UNITED STATES PATENT AND TRADEMARK OFFICE

APPLICATION NO.	FILING DATE	FIRST NAMED INVENTOR	ATTORNEY DOCKET NO.	CONFIRMATION NO.
10/591,320	06/02/2007	Akira Tsuboi	107348-00603	9440

Office Action Summary	Application No.		Applicant(s)	
	10/591,320		TSUBOI ET AL.	
	Examiner		Art Unit	
	RYAN DODD		3655

DETAILED ACTION

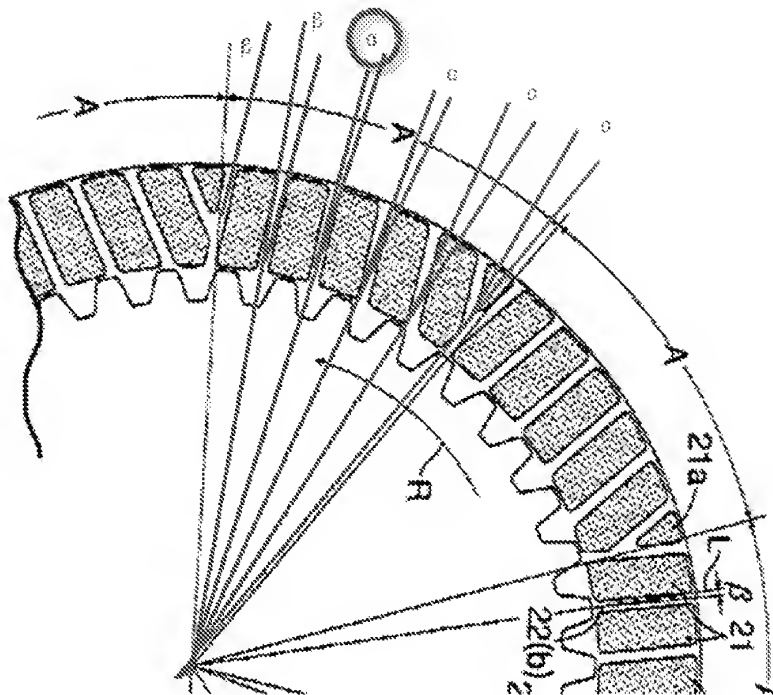
The limitation: “wherein the discharge angle (β) is equal to the inflow angle (α)”, may be interpreted to mean that every angle (β), formed by a radial line (L) of the friction plate passing through and inner end of the discharge oil channel itself (claim 1, lines 11-12), of which there are many (see figure below), is equal to every angle (α), of which there are multiple. Although there are particular angles (β) that may be equal to particular angles (α), the interpretation herein presented is not enabled in such a way as to enable one skilled in the art to make the invention, because every angle (β) is not equal to every angle (α).

Similarly, The limitation: “wherein the discharge angle (β) is less than the inflow angle (α)”, may be interpreted to mean that every angle (β), formed by a radial line (L) of the friction plate passing through and inner end of the discharge oil channel itself (claim 1, lines 11-12), of which there are many (see figure below), is less than every angle (α), of which there are multiple (see figure below). Although there are particular angles (β) that may be less than particular angles (α), the interpretation herein presented is not enabled in such a way as to enable one skilled in the art to make the invention, because every angle (β) is not less than every angle (α).

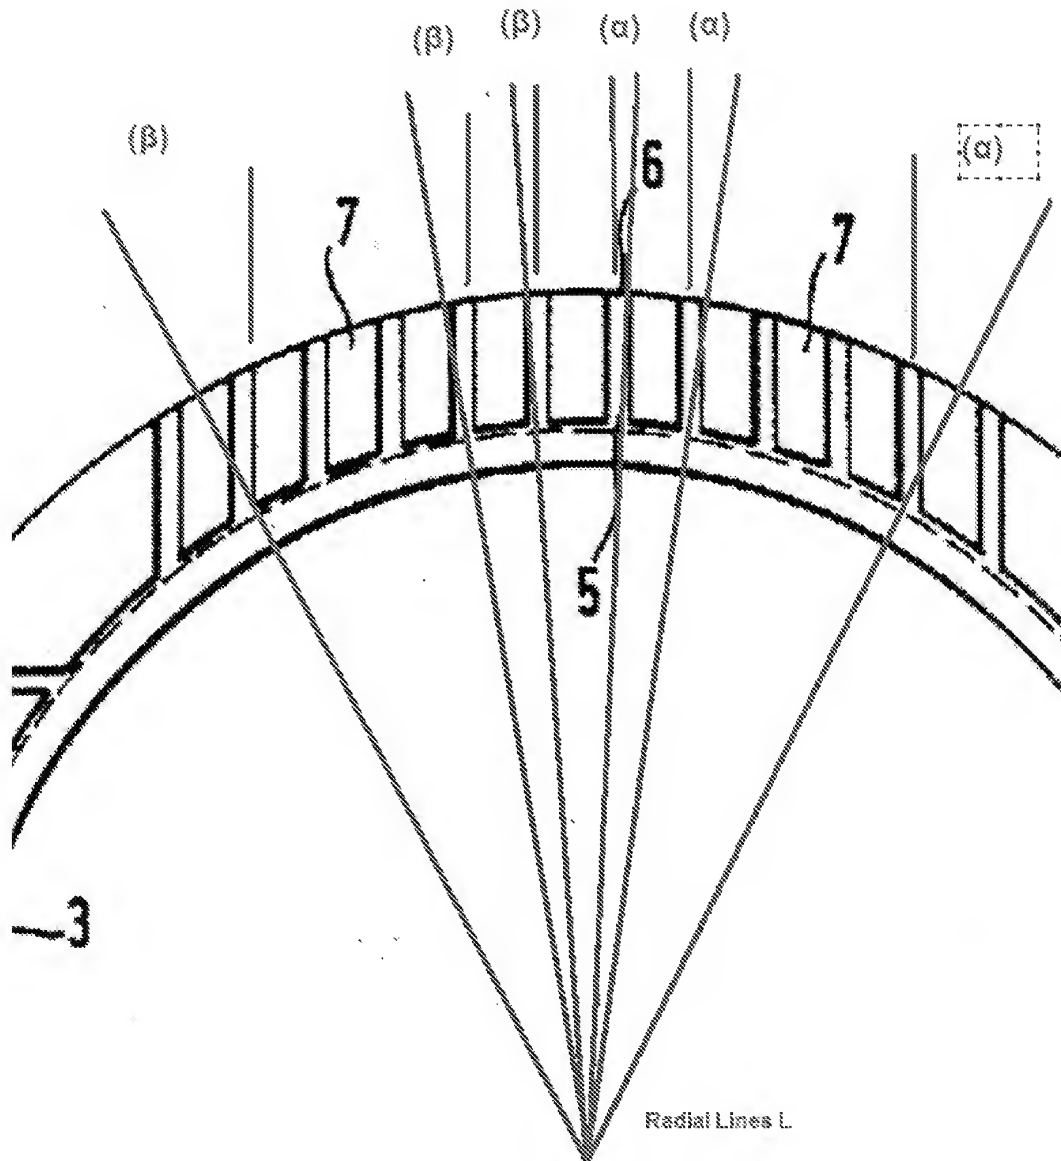
- wherein the plurality of oil channels include a plurality of discharge oil channels having a discharge angle (β) relative to a radial line (L) of the friction plate and which are configured to discharge oil from an inner peripheral side to an outer peripheral side of the friction plate due to a screw pump action that occurs when the friction plate rotates relative to the clutch plate (see Fig. 2, and figure below), and

- the plurality of oil channels further include a plurality of inflow oil channels having an inflow angle (α) relative to the radial line (L) of the friction plate and which are configured to draw oil in from the outer peripheral side to the inner peripheral side of the friction plate due to the screw pump action that occurs when the friction plate rotates relative to the clutch plate (see Fig. 2 and figure below), and

- wherein the discharge angle (β) inclines rearward relative to the radial line (L) and the inflow angle (α) inclines forward relative to the radial line (L) (see Fig. 2, and figure below).

As to **claims 4-9**, as best understood, at least one discharge angle (β) of Bauer '282 is equal to at least one inflow angle (α), and at least one discharge angle is less than at least one inflow angle, as measured from a radial line L (See Fig.2, and figure above).

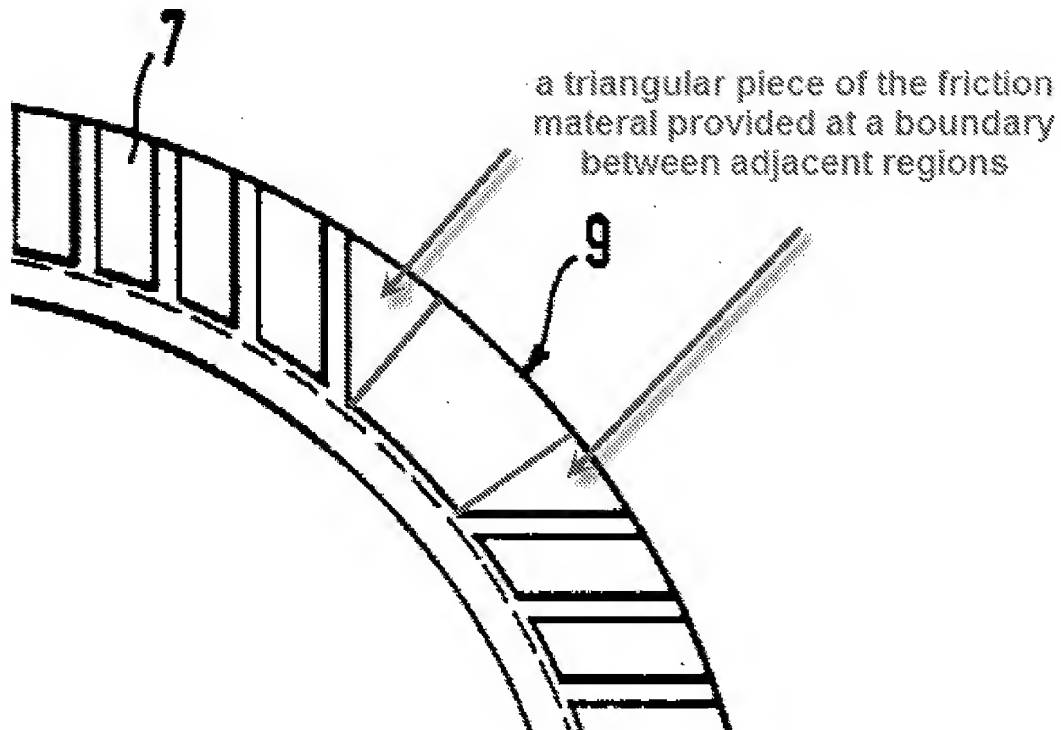
As to **claim 2**, Bauer '282 discloses that the friction plate is divided into a plurality of regions (A) arranged in the peripheral direction, each region including an equal number of discharge and inflow oil channels (for instance in Fig.3 Bauer '282 implies 4 regions).

As to claim 3, Bauer '282 discloses a triangular piece of the friction material that is provided at a boundary defined between adjacent regions (see figure below).
